STAFF RECOMMENDATION
2801 27th Avenue South
July 18, 2018

Application: New construction – infill
District: Hillsboro-West End Neighborhood Conservation Zoning Overlay
Council District: 18
Map and Parcel Number: 11703001000
Applicant: Manuel Zeitlin
Project Lead: Melissa Baldock, melissa.baldock@nashville.gov

Description of Project: Application is to construct infill on a vacant lot. The infill contains an attached garage at basement level.

1 SITE PLAN
1" = 20'-0"

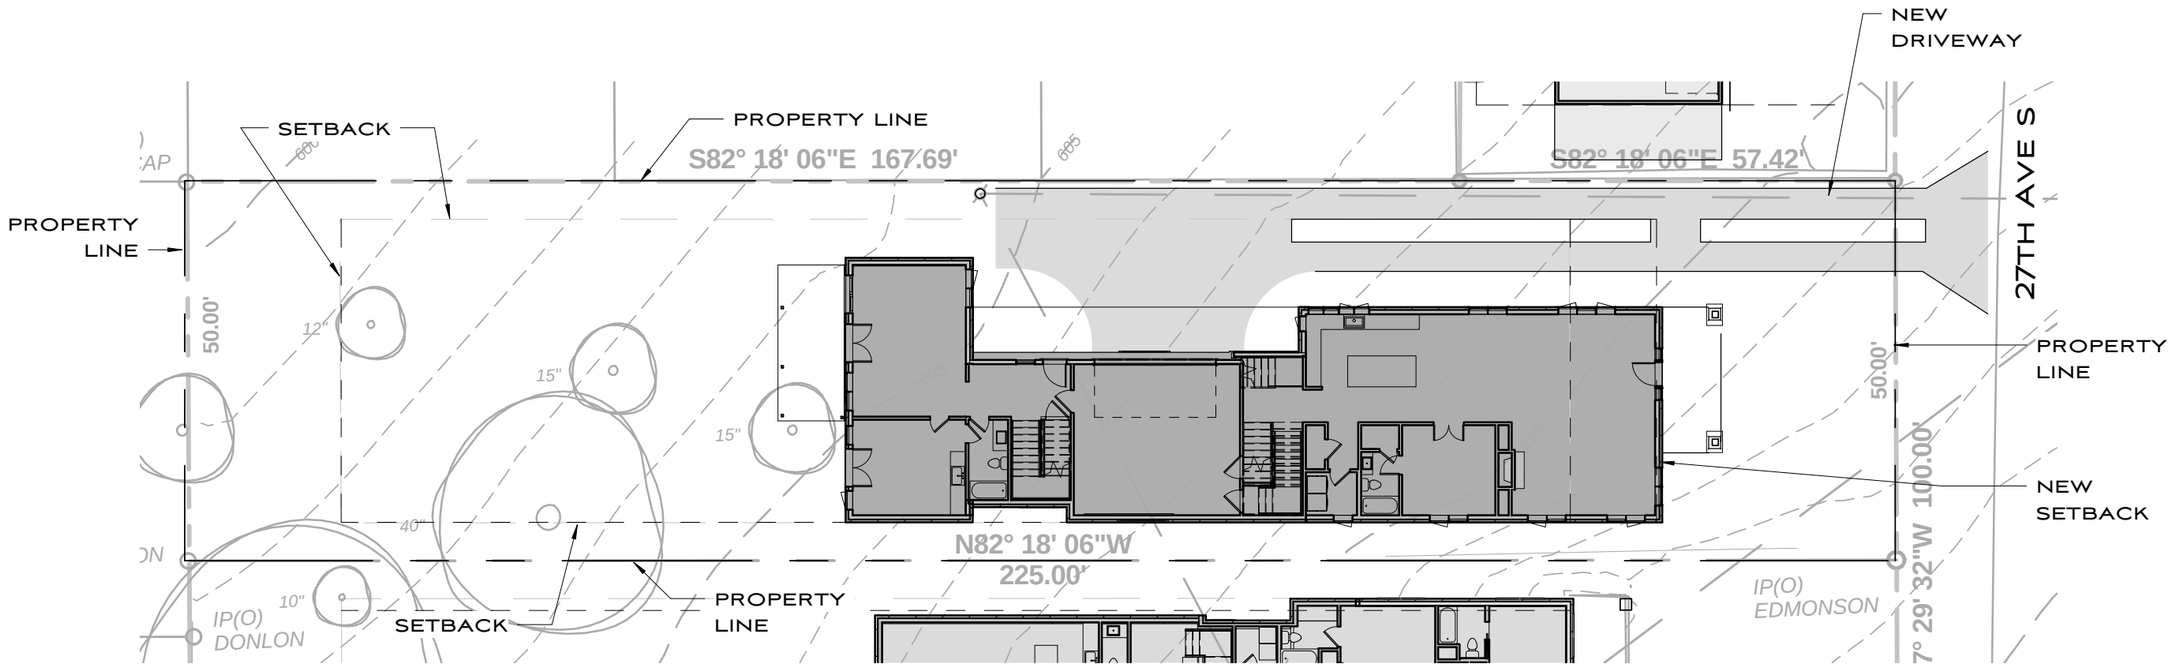
Setback & Rhythm of Spacing: The infill's front setback will be approximately thirty feet (30'), which is approximately twelve feet (12') forward of the historic house next door at 2805 27th Avenue South. Staff finds this to be appropriate because this side of 27th Avenue South does not have a consistent front setback line. The proposed front setback will transition from the corner lot facing Woodlawn to the historic house next door at 2805 27th Avenue South to the unusually deep front setback at 2807 27th Avenue South. Staff recommends an inspection of the front setback when it has been staked to ensure its compatibility.

The infill meets all base zoning setbacks. It will be five feet (5') from the left side property line, and ten feet (10') from the right side property line. It will be approximately seventy-nine (79') from the rear property line. Staff finds that the infill's setback and rhythm of spacing to meet Section II.B.1.c. of the design guidelines.

Orientation: The infill will be oriented towards 27th Avenue South, which is appropriate. It includes an eight foot (8') deep, partial-width front porch. No walkway was included on the site plan, and staff recommends the inclusion of a walkway leading from the street to the front porch.

The site has no alley, so vehicular access will be via a driveway to the right side of the property. The driveway will have concrete strips and will be eleven feet (11') wide, which is appropriate. Staff finds that the infill's orientation meets Section II.B.1.f. of the design guidelines.

Appurtenances & Utilities: A new driveway will be added on the right side of the property, as the site lacks alley access. The driveway will be eleven feet (11') wide with concrete strips, which staff finds to be appropriate. Staff recommends the addition of a walkway from the street to the front porch. The location of the HVAC and other utilities was not noted. Staff recommends that the HVAC be located on the rear façade, or on a side façade beyond the midpoint of the house. With the staff's approval of the HVAC location and the inclusion of a front walkway, staff finds that the proposed appurtenances and utilities meet Section II.B.1. i. of the design guidelines.

1. The finished floor height shall be consistent with the finished floor heights of the adjacent historic houses, to be verified by MHZC staff in the field;
2. Staff approve the front setback in the field after staking;
3. Staff approve the final details, dimensions and materials of windows and doors prior to purchase and installation;
4. Staff approve brick and stone samples;
5. Staff approve the material of the front porch floor and steps;
6. Staff approve the roof shingle color, material, and texture;
7. A walkway be included from the street to the front porch, and staff approve the walkway material;
8. All double window openings have a four to six inch (4"-6") mullion in between them; and
9. The HVAC shall be located behind the house or on either side, beyond the mid-point of the house.

2 FRONT ELEVATION
1/8" = 1'-0"

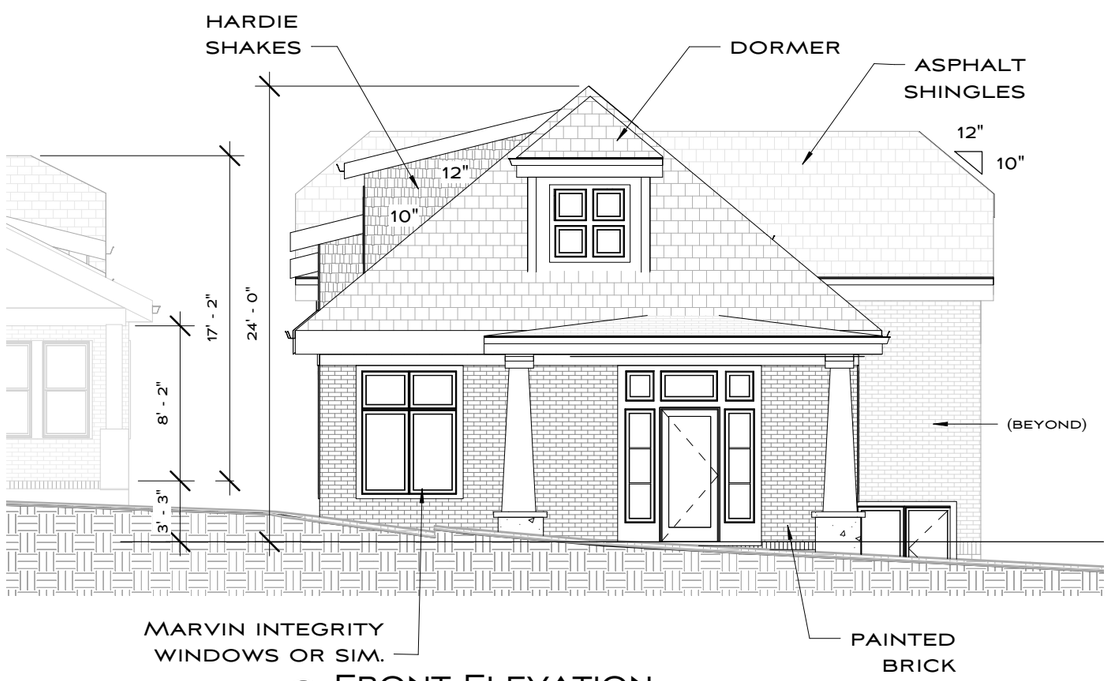
Height & Scale: The proposed infill is one-and-a half-stories in height at the front. It has an eave height of approximately ten feet (10') at the front from the foundation line and a ridge height of approximately twenty-four feet, six inches (24' 6") from the foundation line. Staff finds that the infill's height meets the historic context where houses range in height from nineteen and twenty-eight feet (19'-28') in height.

Roof form: The house's primary roof form is a hip with a 10/12 slope. This is similar to the roof of the historic house next door at 2805 27th Avenue South. The porch roof will also be hipped with a 2/12 slope. The front dormer will be hipped with a 10/12 slope, while the side shed dormer will have a 3/12 pitch. The side shed dormer is inset two feet (2') from the wall below, as is typically required. The wider portion of the infill will have a clipped gable form with a 10/12 slope.

Proportion and Rhythm of Openings**:** The windows on the proposed infill are largely twice as tall as they are wide, thereby meeting the historic proportions of openings. There are no large expanses of wall space without a window or door opening. Staff recommends that all double window openings have a four to six inch (4"-6") mullion in between them. With the condition that all double window openings have a four to six inch (4"-6") mullion in between them, staff finds the project's proportion and rhythm of openings to meet Section II.B.1.g. of the design guidelines.

1 SOUTH ELEVATION1
1/8" = 1'-0"

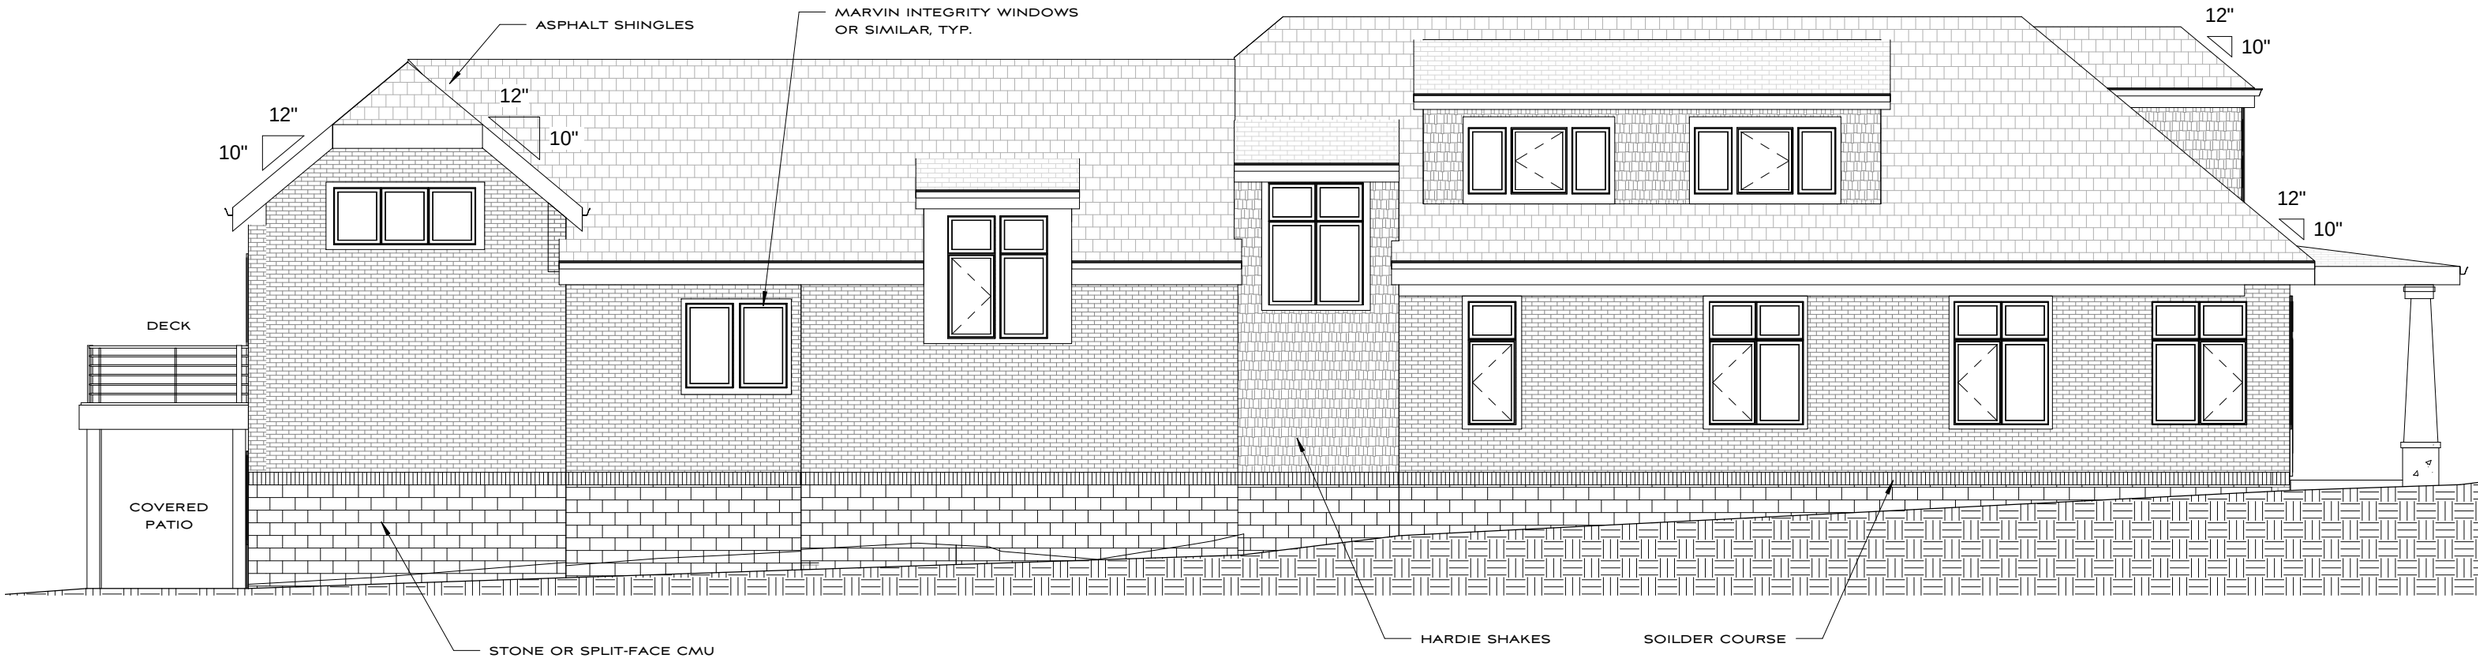
The site slopes towards the back so at the rear there is an occupied basement level. The foundation height is shown as minimal at the front and gets taller further back on the site because of the slope. Staff recommends approval of the foundation height and first floor framing height in the field to ensure that the foundation and floor heights are compatible with the immediate historic context.

The side elevations contain wall dormers, which are not typically approved. Staff, however, finds these wall dormers to be acceptable, in this instance, because they are located over fifty-six feet (56') back from the front wall of the house and will not be highly visible. Staff finds that the proposed roof forms meet Section II.B.1.e. of the design guidelines.
